Re: Brookside Road CDN/21/0610

The applicant has responded to your initial assessment and has stated the following:

Please find our consultants response to the comments on condition 18 below:

Figure 6 — Geometrical quantities for determining the pathlength difference for single diffraction

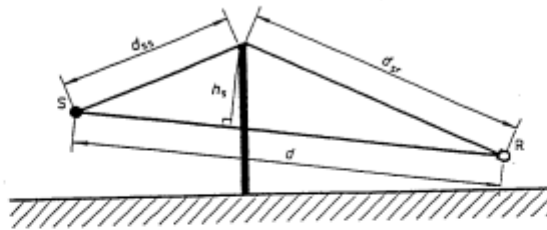
In terms of the 15dB attenuation for screening stated in Table 4.2 I have used the following calculation method presented in ISO 9613-2:1996 'Acoustics – Attenuation of sound during propagation outdoors – Part 2: General method of calculation'. See below.

This is quite an involved calculation for which we have developed a spreadsheet. The reduction of 15dB I have used was actually 17dB theoretically, however, it is good practice to use the maximum reduction from a barrier of -15dB.

Figure 7 — Geometrical quantities for determining the pathlength difference for double diffraction

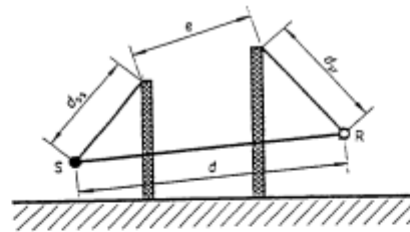
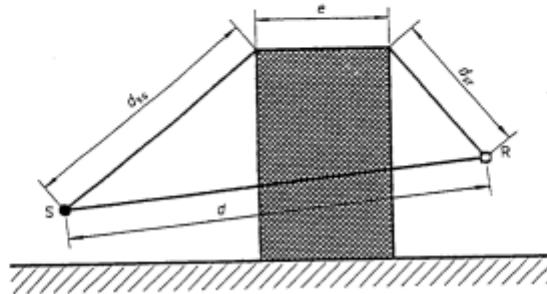
For double diffraction, as shown in figure 7, the pathlength difference z shall be calculated by

$$z = \left[(d_{ss} + d_{sr} + e)^2 + a^2 \right]^{1/2} - d \quad \dots (17)$$
